5.3. RECONFIGURATION OF A LOT - 1 INTO 72 LOTS (PLUS PARK), VIXIES ROAD, WONGA BEACH

PROPOSAL Reconfiguring a Lot (1 Lot into 72 Lots) plus Park

RECOMMENDATION

ATTACHMENT 1 – APPROVED PLANS

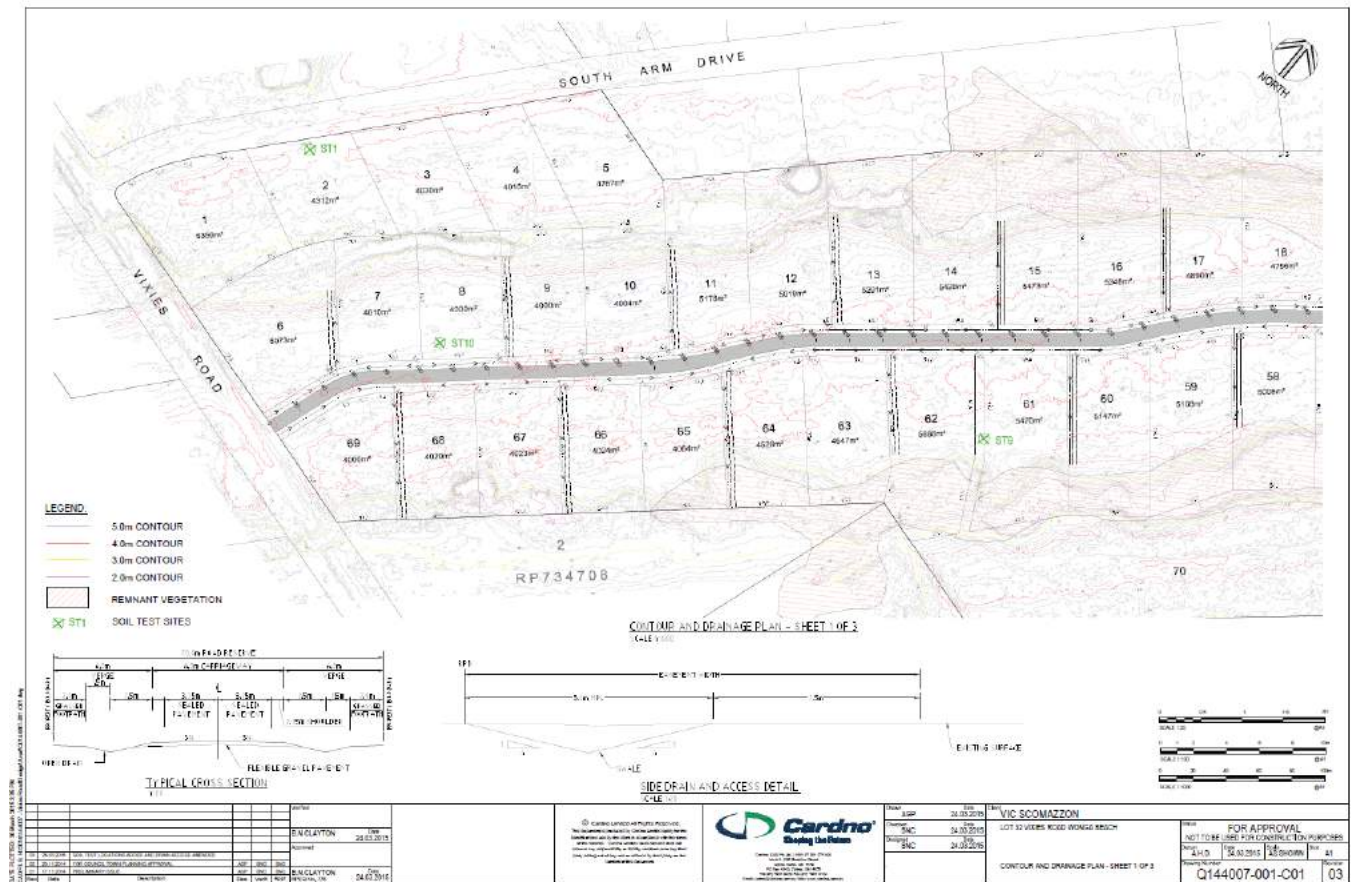
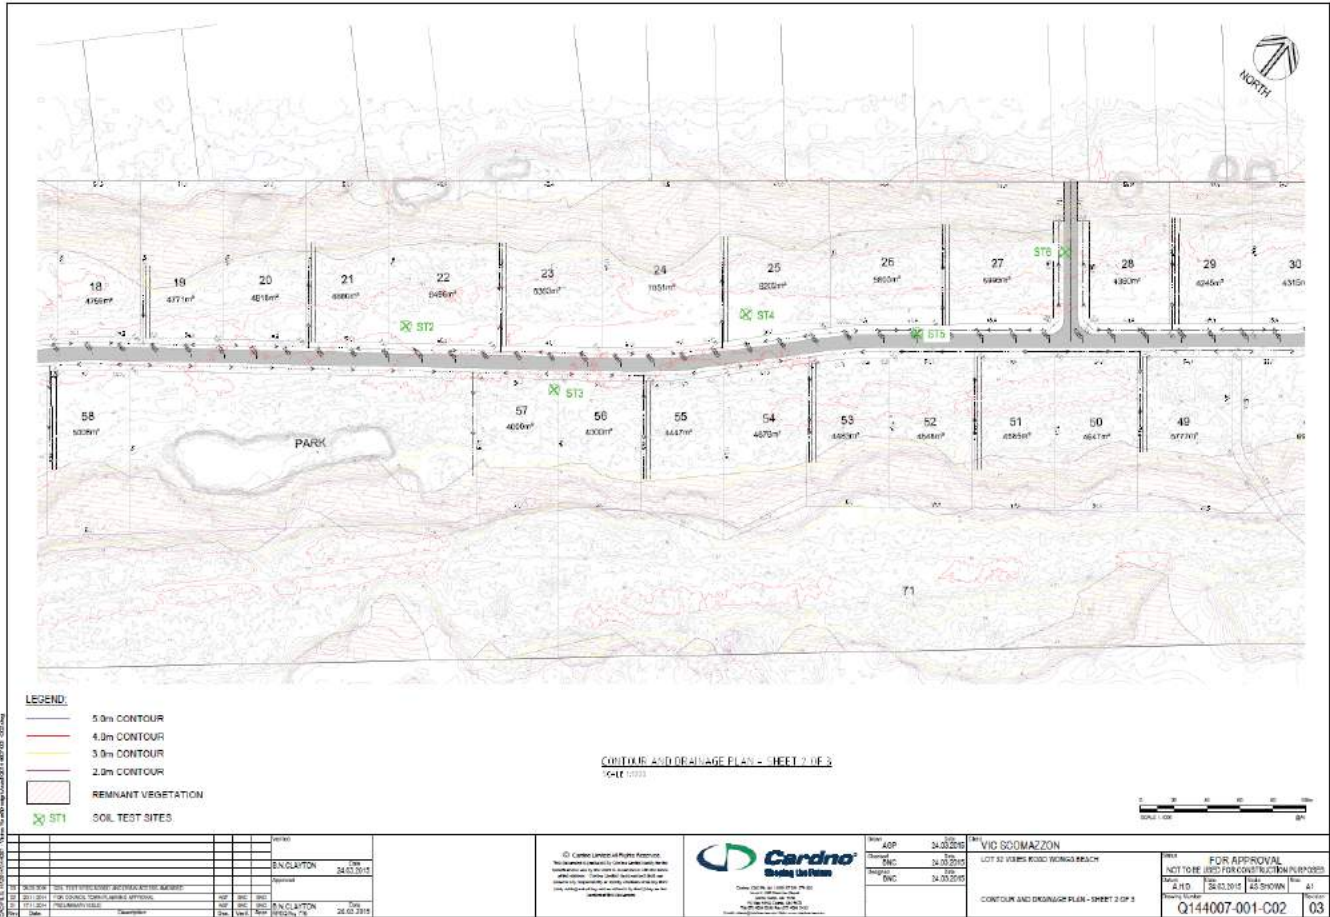
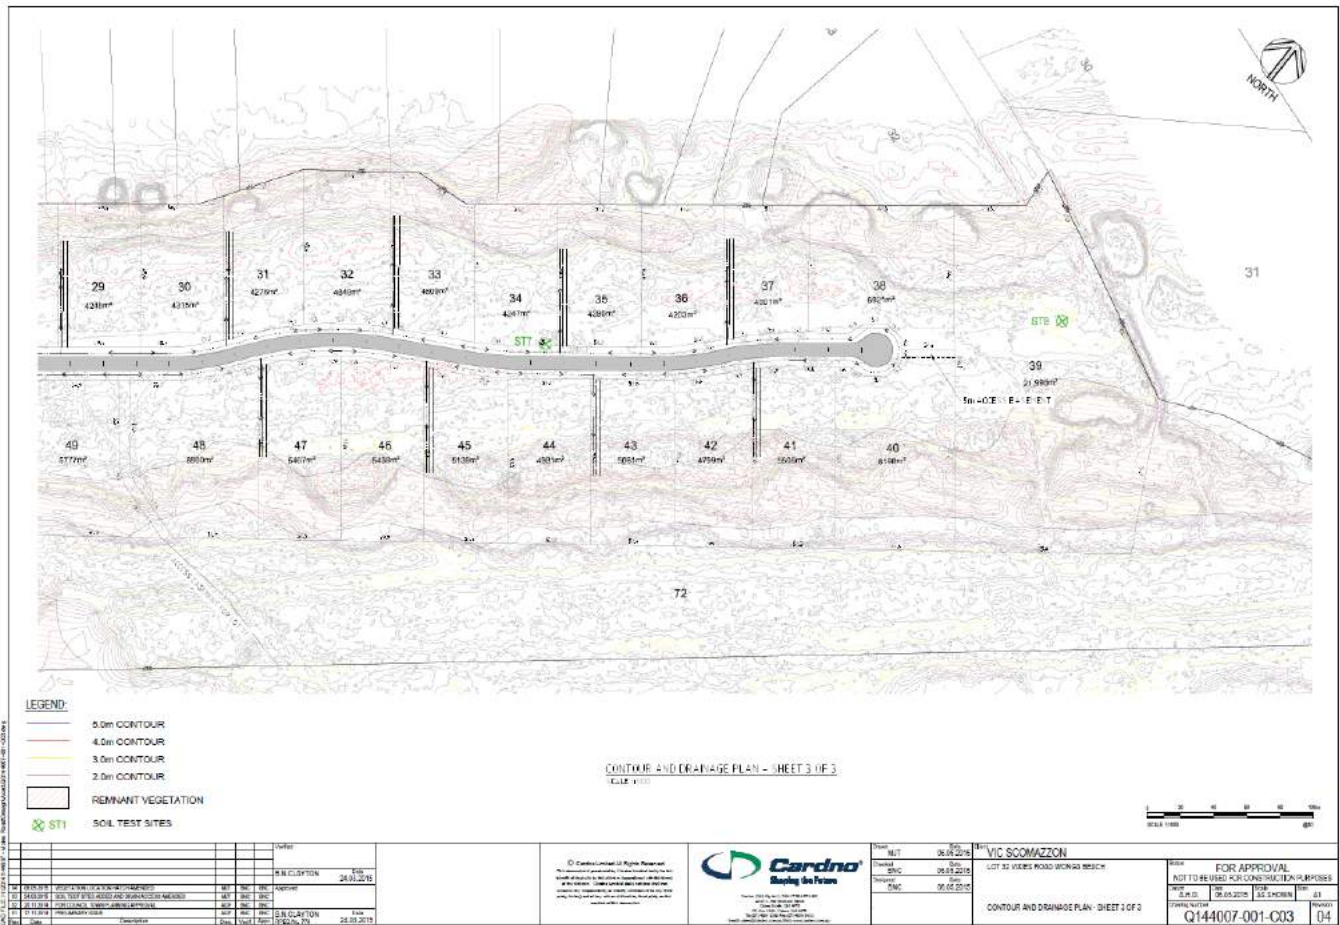
3. The street layout and design is to be generally in accordance with Cardno Drawings Q144007-001-C01 to C03 subject to any amendments to comply with conditions, Queensland Streets and the FNQROC Development Manual, to the satisfaction of the Chief Executive Officer. In particular:

- a. Design and construct the internal road servicing lots 6 to 72 in accordance with the FNQROC Development Manual and generally in accordance with the Cross Section as detailed on Drawing No. Q144007-001-C01 subject to the construction of a 7 metre sealed pavement with 1 metre gravel shoulders.

- a. Drainage infrastructure generally in accordance with the concepts shown on Cardno drawings Q144007-001-C01 to C03 Revision 3 & 4 subject to amendments required to comply with the FNQROC Development Manual. Calculations of the sub-catchment discharge and the flow width and depth in roadside drains and easements must be provided prior to the issue of a Development Permit for Operational Works. The calculations must demonstrate that the flows are fully contained in the drainage paths and do not enter private property except where easements exist;

11. The area identified as Park on Drawing No. Q144007-001-C02 / 03 is not suitable to be dedicated as Park due to the characteristics and location of the land. The land could form one additional residential lot within the development.

Figure C7

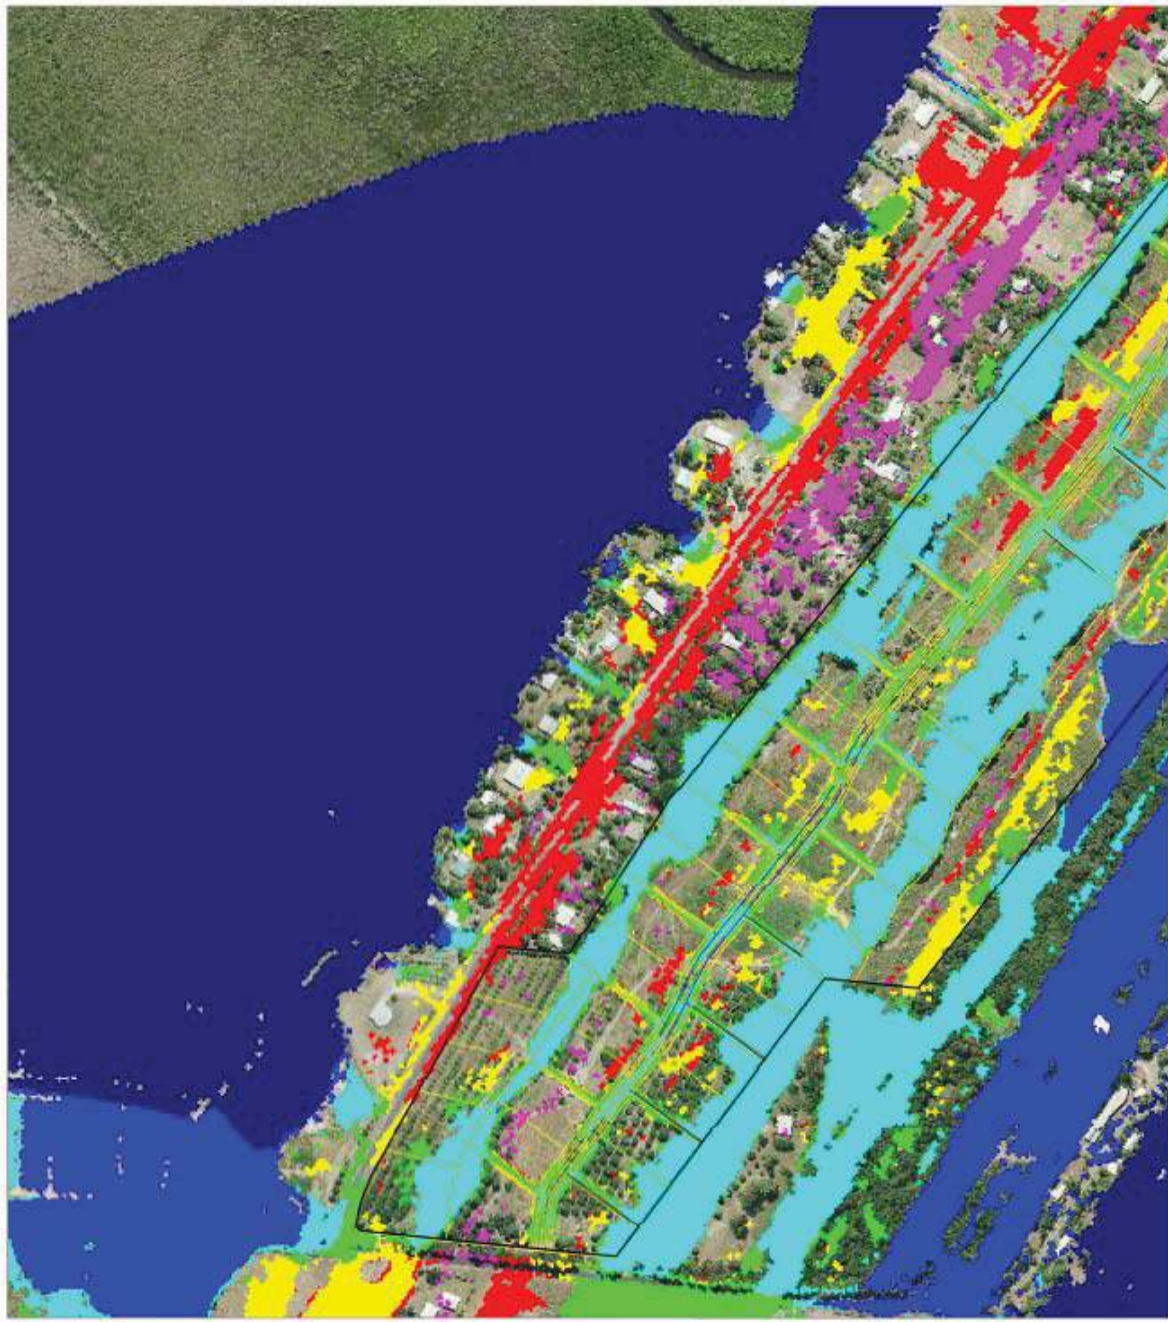
Plans from the flood study for the site illustrating both pre and post development flood levels form Attachment 5. Plans C7 & C8 of Attachment 5 illustrate the extent of flood inundation for the event with the most impact as identified above. It must be noted that these plans represent the Q100 surface level but doesn't provide information on the depth or significance of inundation. To gain an appreciation of these characteristics, refer to Plans C5 & C6.

These plans illustrate flows being largely contained to the drainage swales with isolated and scattered areas of inundation within the proposed lots (excluding the drainage swales). The analysis suggests that the extent of inundation within the lots is less than 250mm and would be reflective of depressions and localised variations in ground levels. Minor earthworks of grading and levelling the land would overcome these issues and therefore are not significant.
